KARACHI MUNICIPAL CORPORATION.

Case No. C.457/27 Plot No. 453, Jm3 Jang

REVIEW FORM.

Case No. *453* *457/38*
RE:—Plot No. *453*, Sheet No. *3*, *James* Qr.

RECOMMENDED PLAN

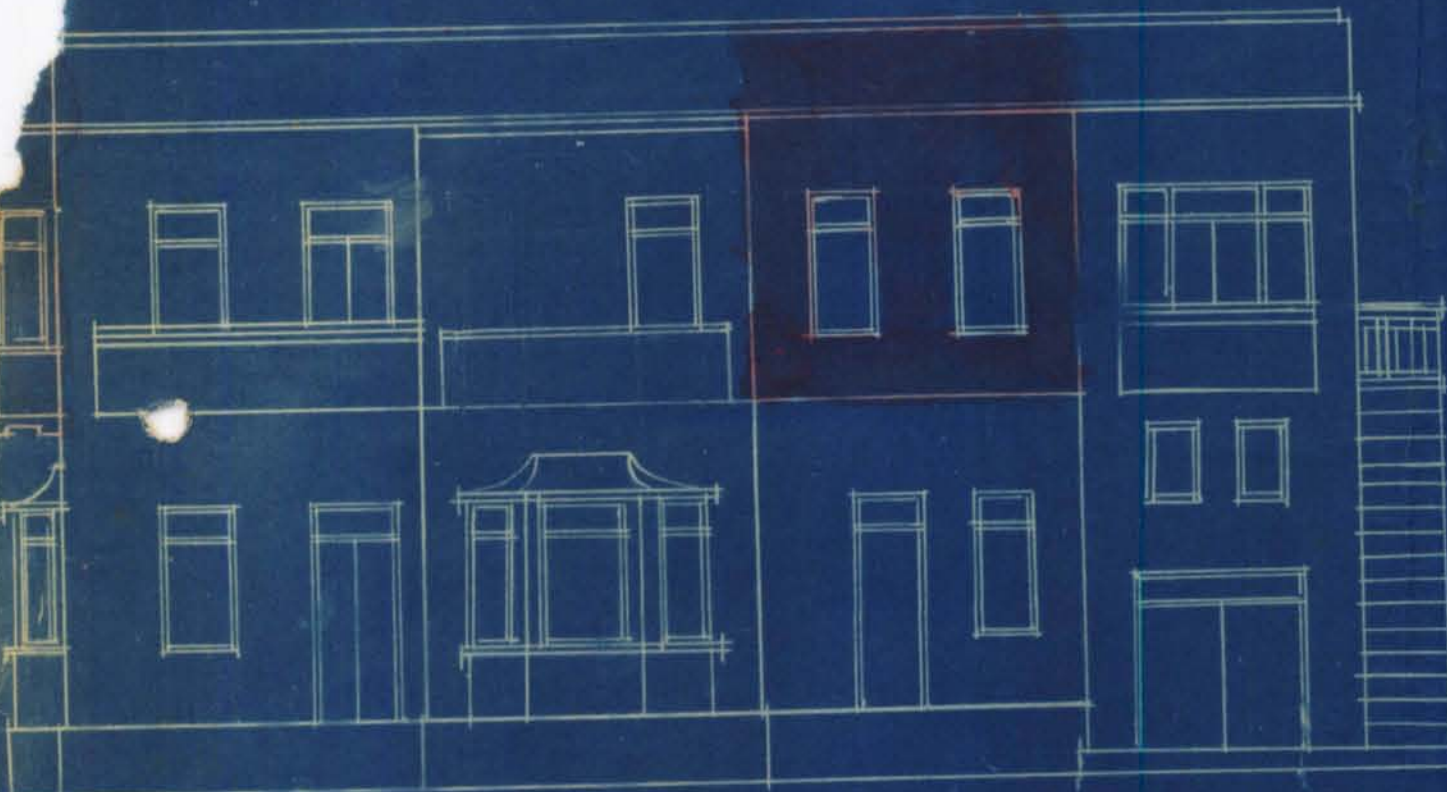
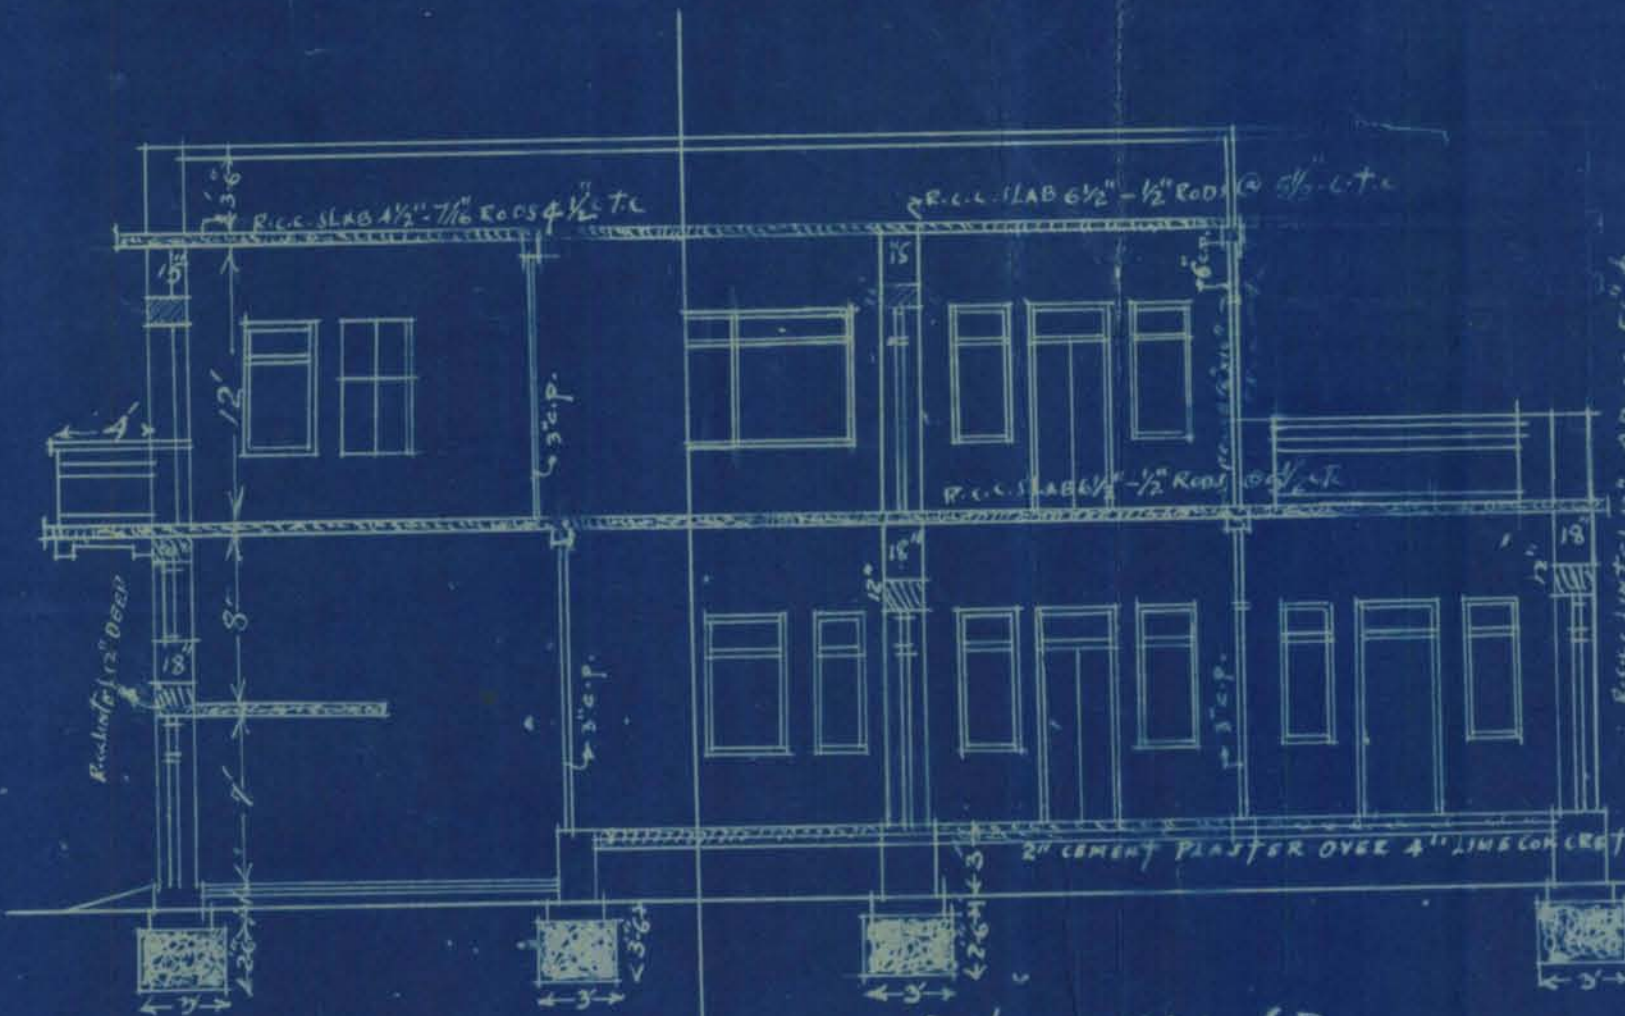
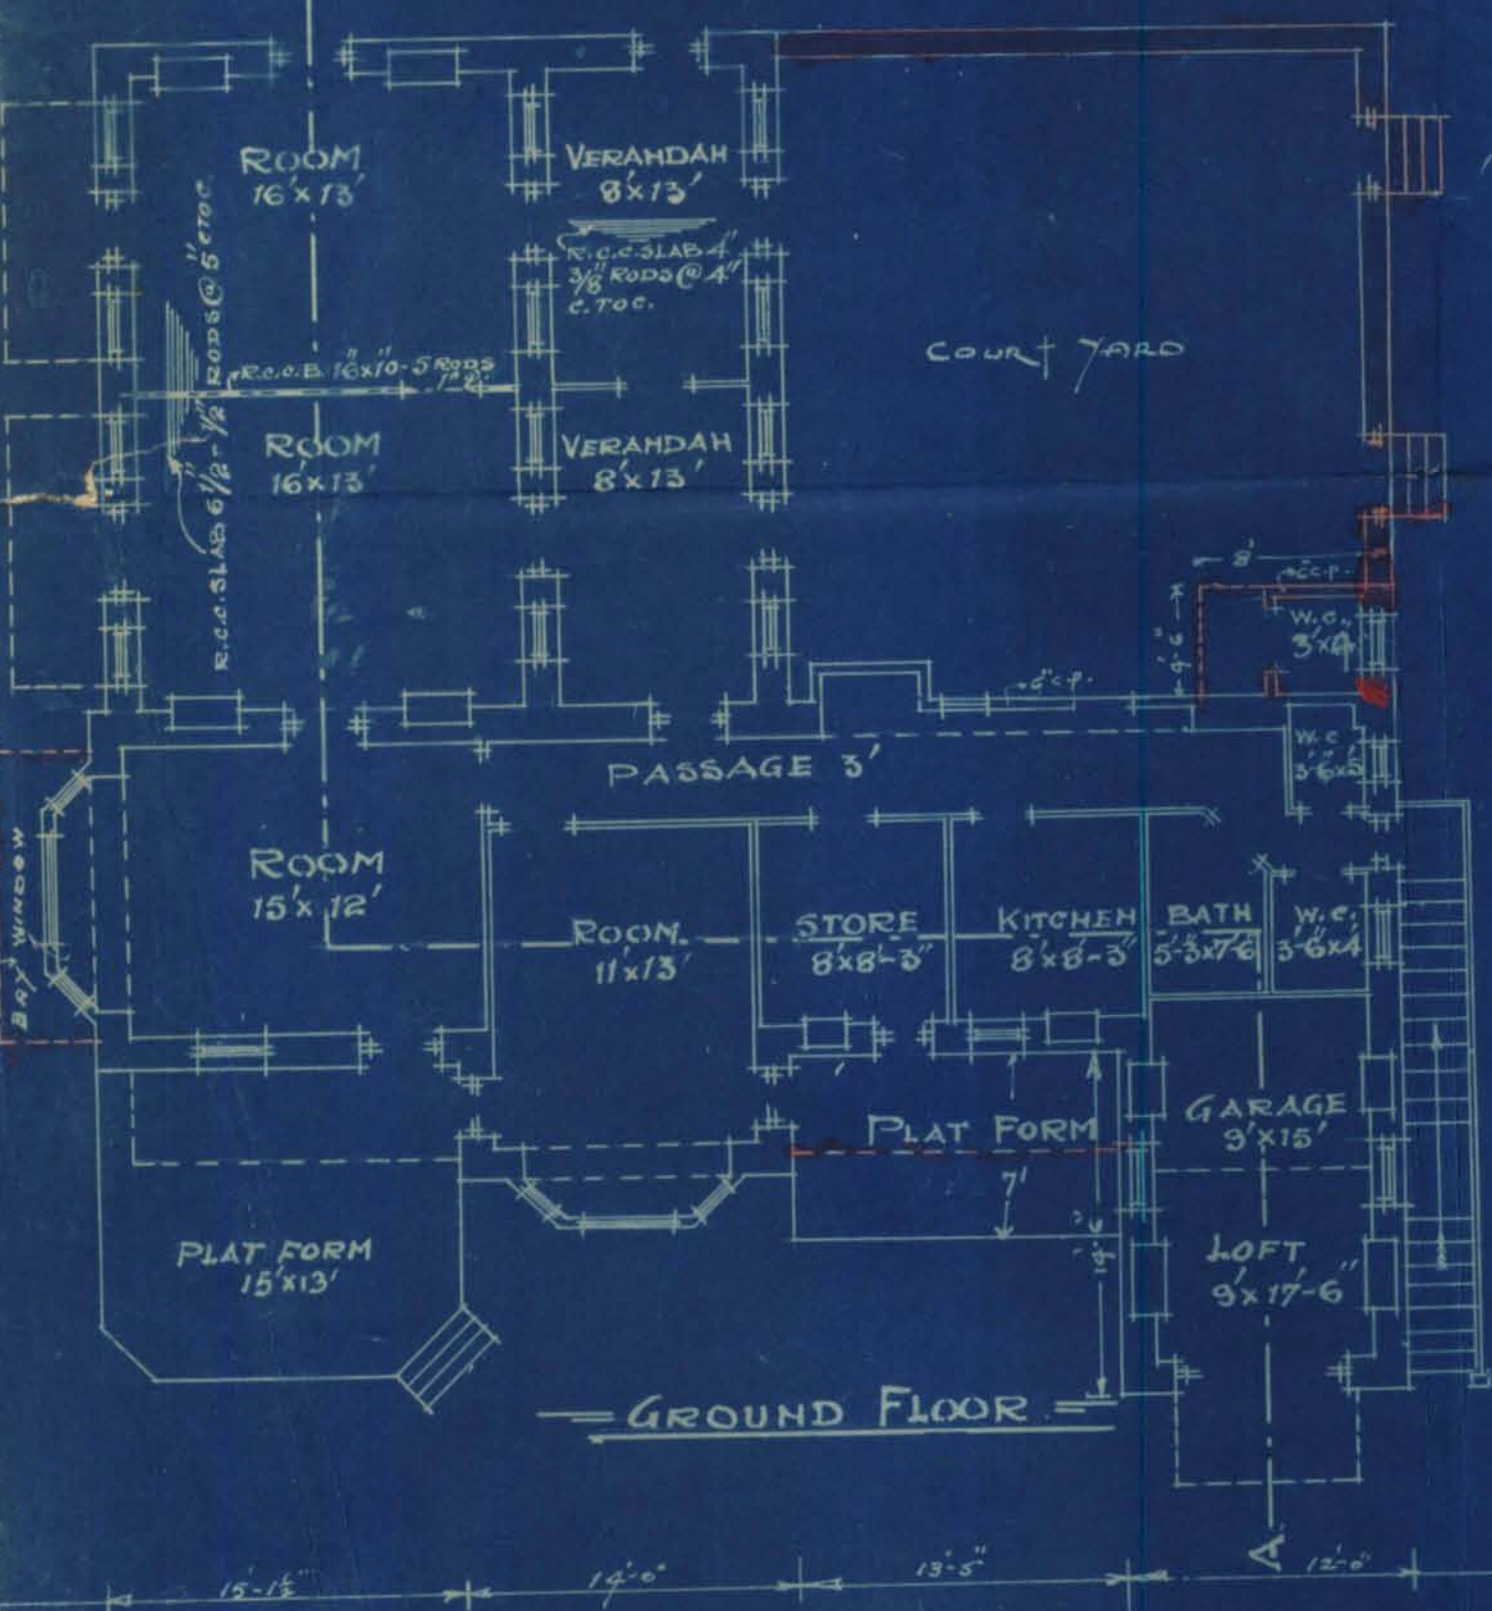
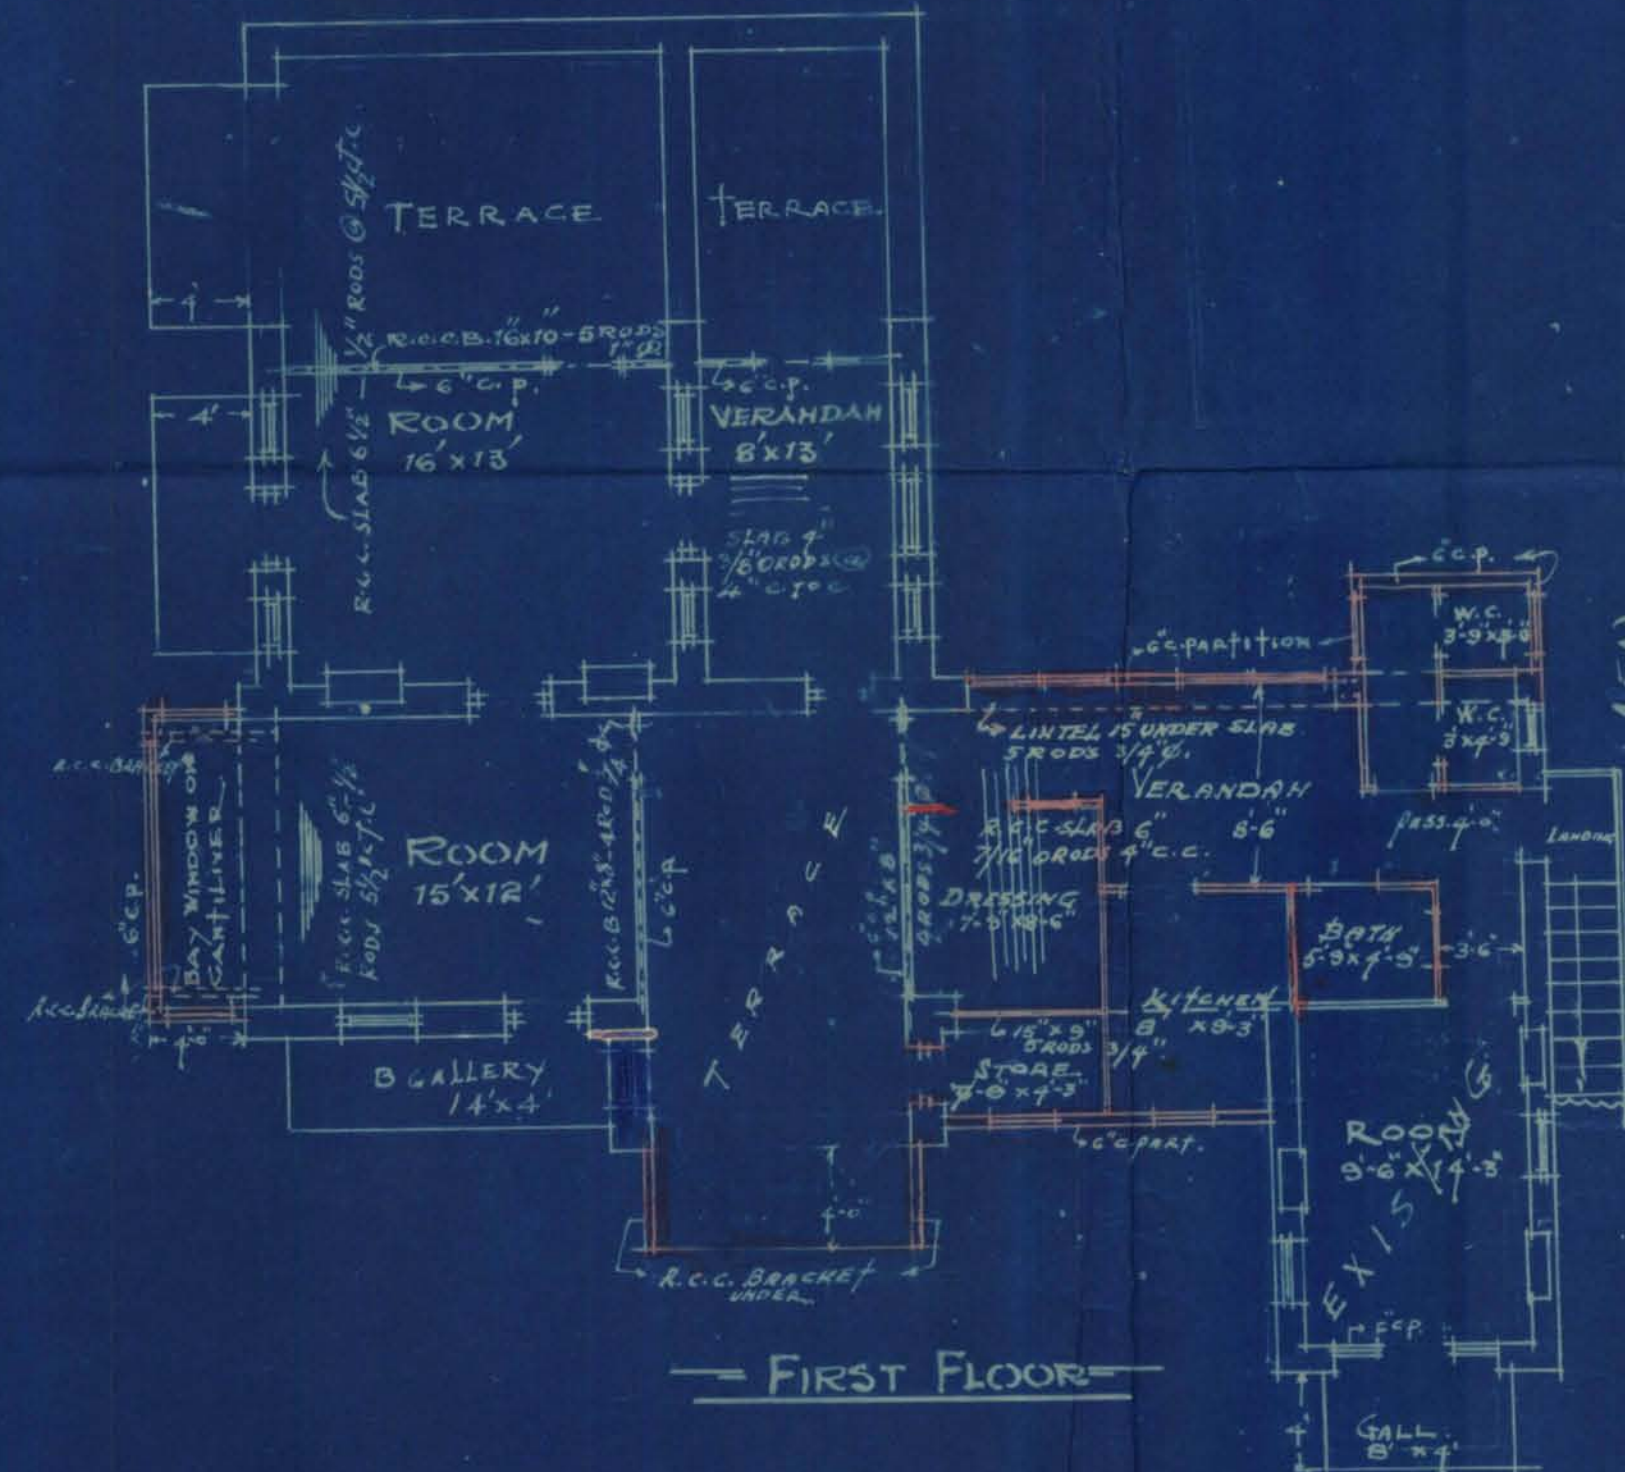
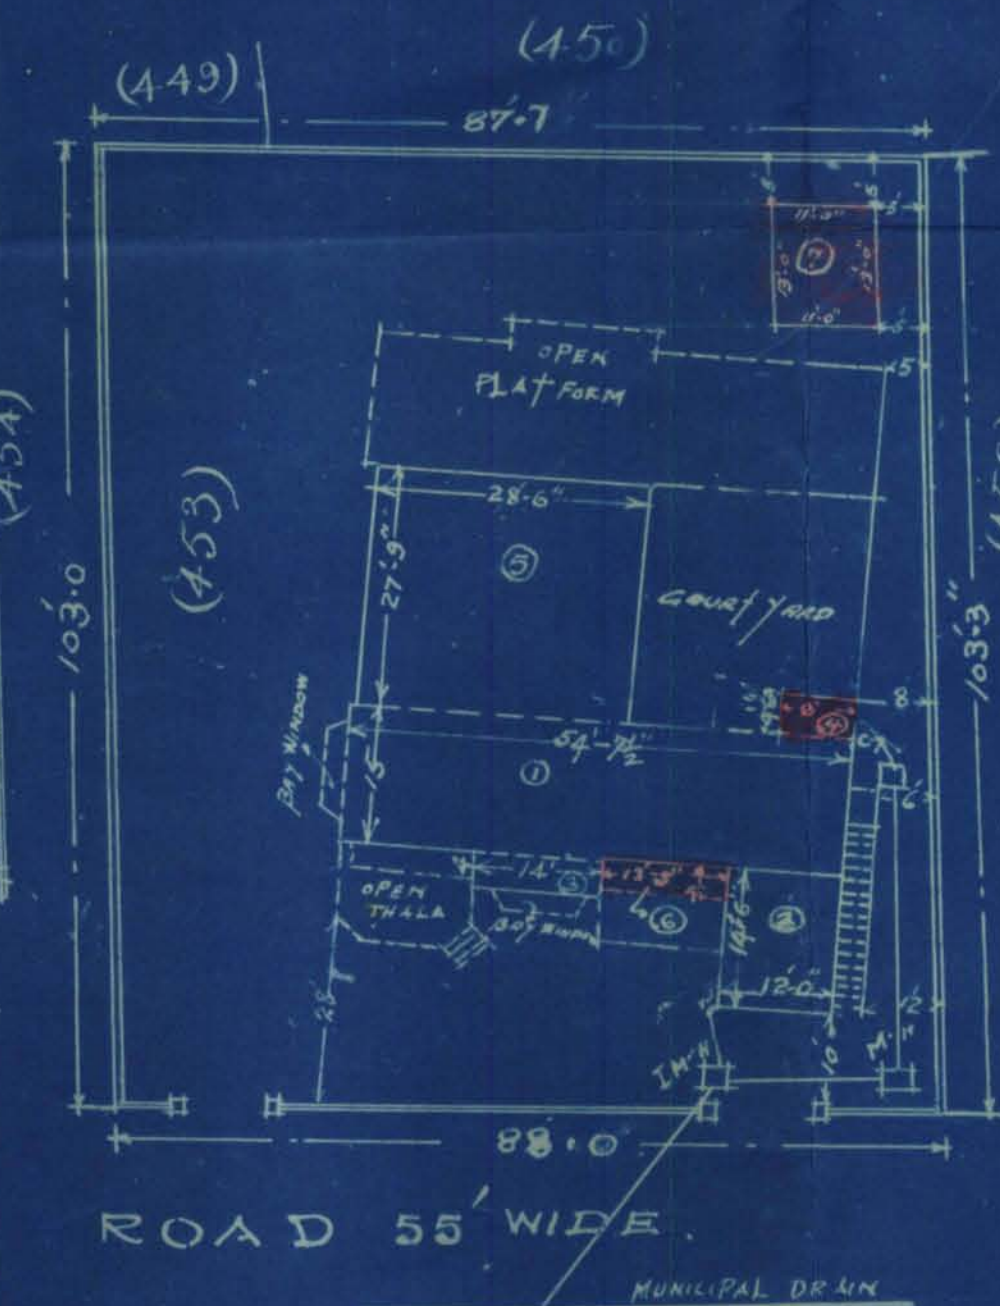
1. Fresh application should be made on A form
2. All the proposed work should be coloured red
3. Built up area should be checked with BS.

1. Fresh application should be made on 'A' form.
2. All the proposed work should be coloured red.
3. Built up area should be checked with the Building Surveyor.

- (1). " A " form is sent herewith .
- (2). Amendments proposed to the already
sanctioned plan are coloured red.
- (3). Built up area can be checked at
the end when the building is completed.
There is still area to be built upon.
